XIT-284

Maria de la M	C SPECIFICATI	ON	NO. S	1101	
REV: DA BCD					
COMPILED:	CHECKED:	APPD:	SHEET	1 OF	3
TITLE: KIT 284			777		<del></del>
Typed 5/18/6	66 by Carol M. Smith

I This modification affects transmitters AN/FRT 39, AN/FRT 40 and AN/FRT 62. It involves changes to the high voltage warning light, AX 124, to correct a safety hazard.

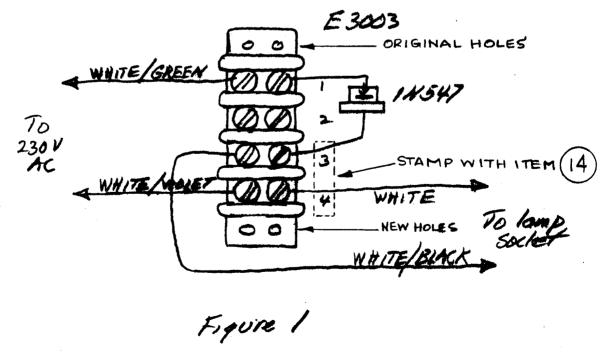
- (i) Remove meter box and meter panel intact and support same so that no stress will be on cabling. Two spacers behind meter box will also drop free. They must be re-installed after completing modification.
  - (j) Disconnect wiring from existing terminal strip E3003.
- (k) Position the new terminal strip near the existing E3003 and using item 2 as a guide, drill four holes in top RF shield with a #36 drill bit. Mount the new terminal strip, Item 2 and its insulator strip, Item 3, using four self tapping screws, Item 16. Stamp terminals 1, 2, 3, and 4 per figure 1, using Item 14 and 15. Proceed to step B. 4. after modifying warning light.

- 1. Disconnect and remove terminal strip E3003 on the top shield of the auxiliary frame (LD551/MS1604). Save mounting hardware.
- 2. Using the new 4-terminal strip, TM102-4, Item 2, as a guide, drill two new .175 dia. holes as shown on drawing MS1604.
  - 3. Mount Item 2, using hardware saved from step 1, above, and Item 3 (PX336-4). Stamp additional terminal numbers with Item 14.
- 4. Mount diode, 1N547, Item 1, between terminals 1 and 3 of the new E3003 as indicated on Figure 1.
- 5. Reinstall top cover if removed, then the modified bight accembly many original gastet, muts and washers.
- 6. Connect leads to E3003 as shown in Figure 1, below. Check light operation.
  - 7. Reinstall all sitems and equipment removed to perform modification.
